557 Riverside St.

Tabernash Station Shop

DATE	May 26, 1988
JOB NO.	
ATTENTION	David Klink, City Planner
RE:	PORTLAND WEST

SUBJECT: 557 Riverside Street Site Plan

PLAN OF PROPOSED INTERSECTIONS

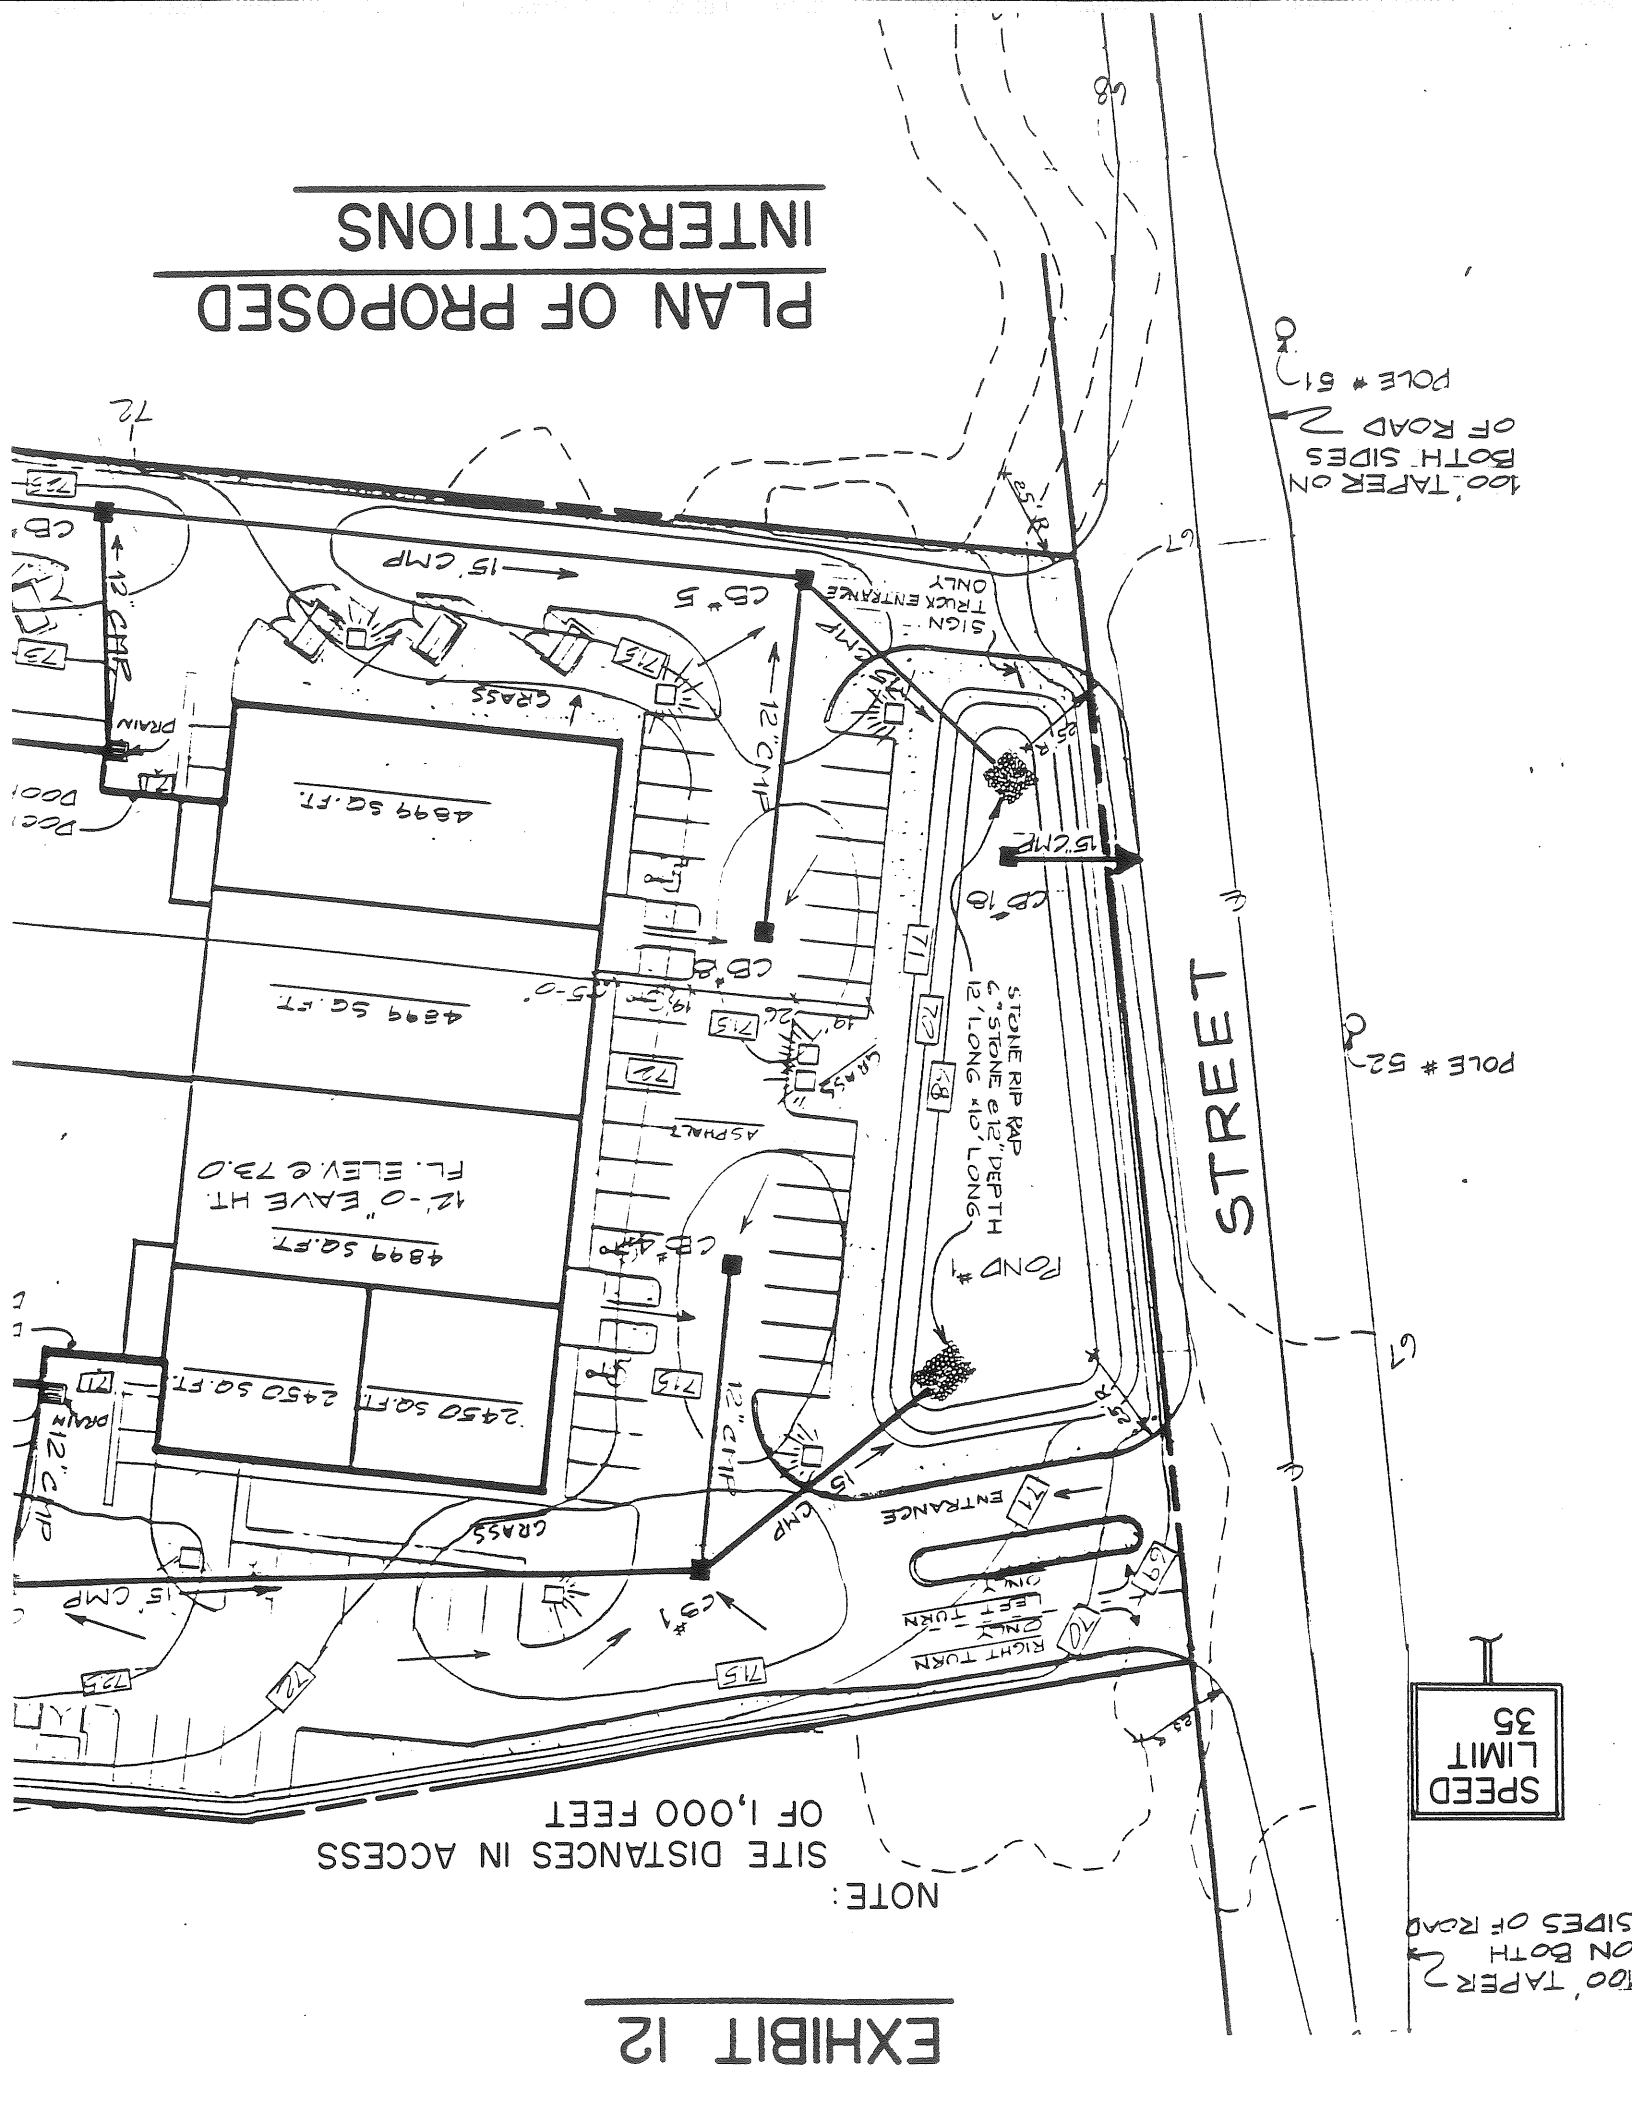
- Traffic: 75' travel lanes added to both directions of Riverside Street.
Lanes in both directions on both sides of Riverside Street.
Granite curb extended to include the added 75' of travel
Note added concerning construction standards.
Taper length increased to 245'.
- Drainage: Pond 1 outfall connected to 24" pipe at opposite side of road.
Riprap shown on pond edges.
Added pipe around pond 2.
- Landscape: Added screening along north property line.
Added landscape along south property line.
Detail plan at 20 scale.
Caliper size increased to 2 1/2" - 3".

PARTIAL LANDSCAPE PLAN
 SCALE 1" = 20'-0"

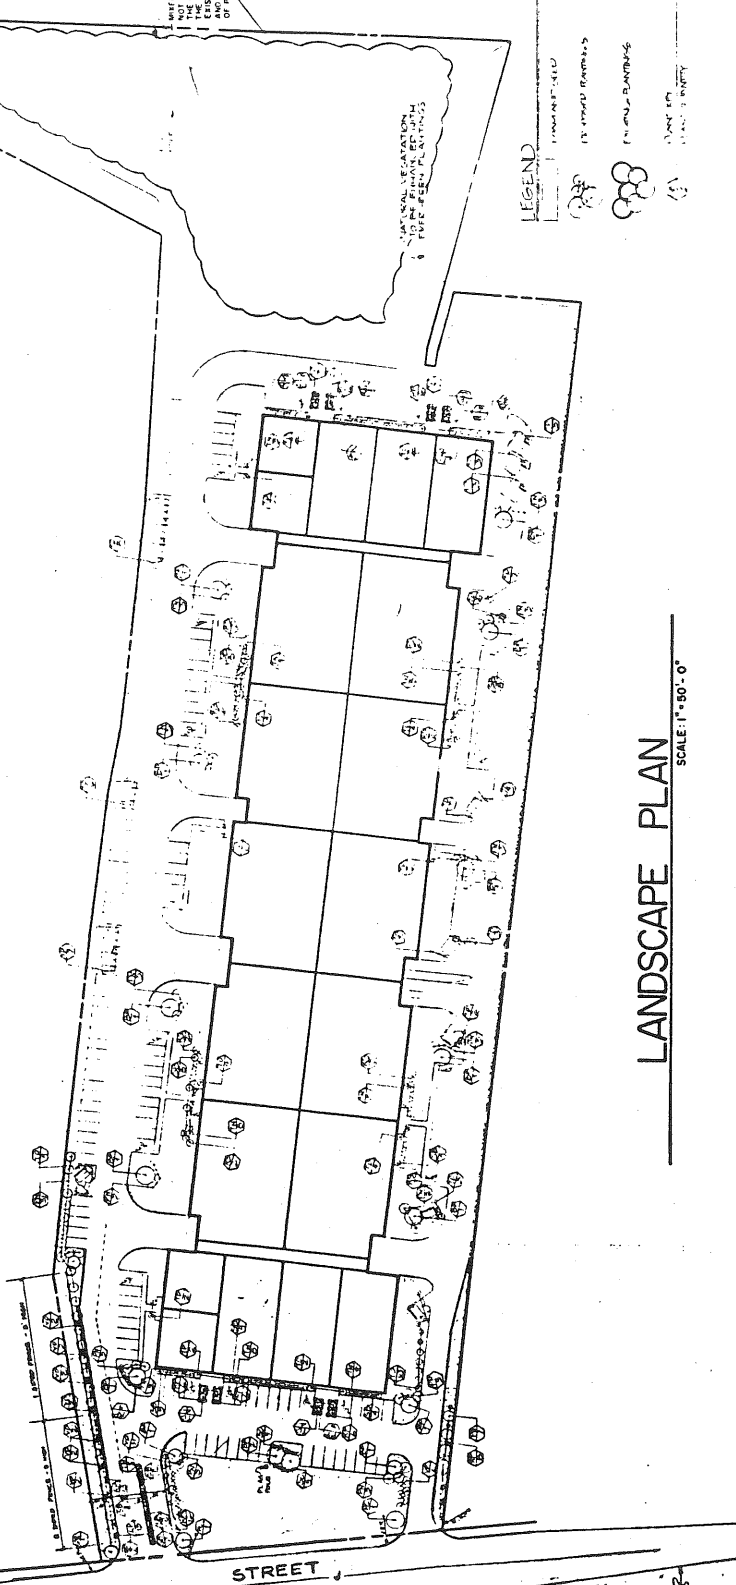
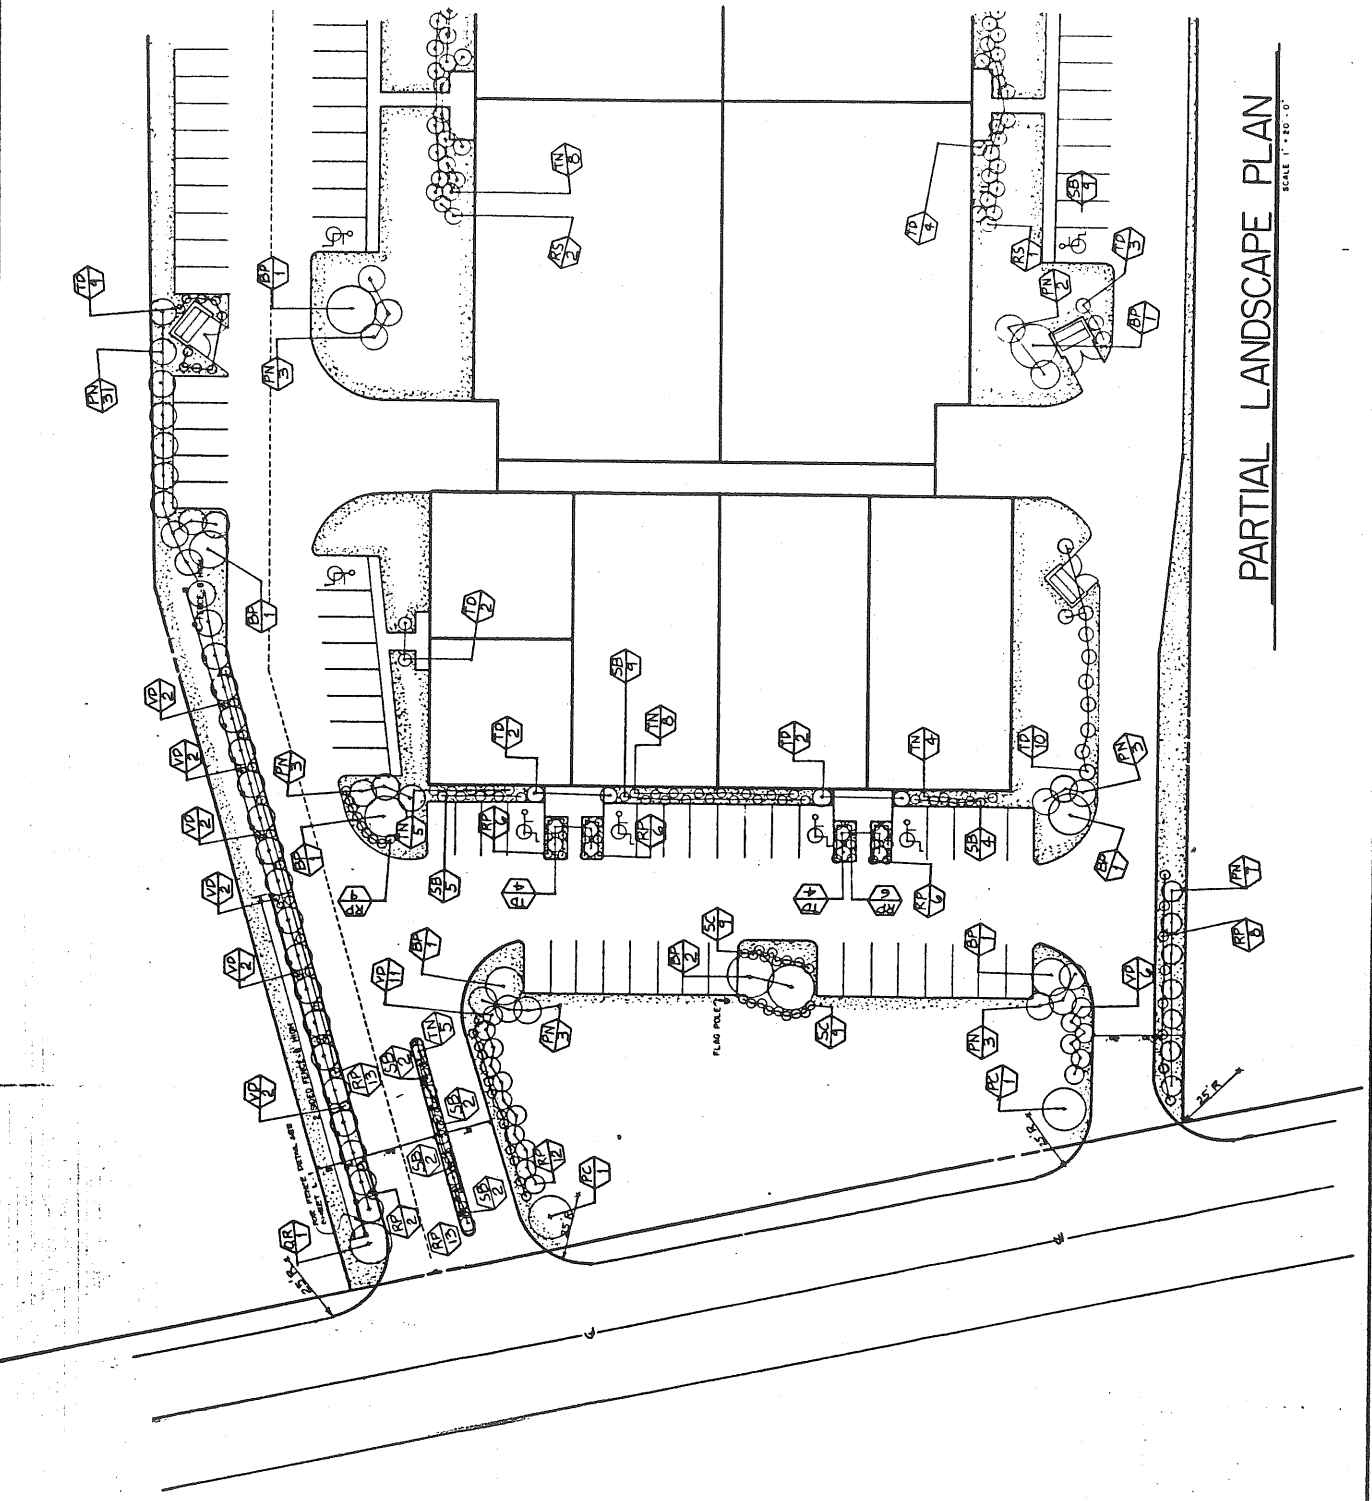
The entire existing vegetated area near the turnpike is recommended to be marked as a preservation area with trees marked and inspected by the City Arborist prior to construction. Additionally, 125 trees should be planted in this area to mitigate the loss of mature vegetation that has been removed from the site. The location of these trees is to be shown on a revised site plan and approved by the City

The additional planting should be White Pines six to seven feet in height minimum.

3. The additional plantings proposed at the rear should be of the Pinus Strobus (White Pine) species. These species should also be clarified in reference to the location of planting. The size of this species should be 6'-7' in height at a minimum.

Additionally, 125 trees are to be planted in this area to mitigate the loss of the mature vegetation that was on the site. These trees are to be shown on a revised site plan and approved by the City Arborist.

REMARKS: **DAVID:**
 ① THE LANDSCAPE? TAKE CHANGES HAVE BEEN AGREED BY THE THIBAUMUS
 ② SOME DUMPSTERS HAVE BEEN REMOVED
 ③ 125 TREES HAVE BEEN ADDED TO THE I-95 SIDE OF THE PROJECT.
 ④ THE SIGN WILL MEET APPLICABLE CODES
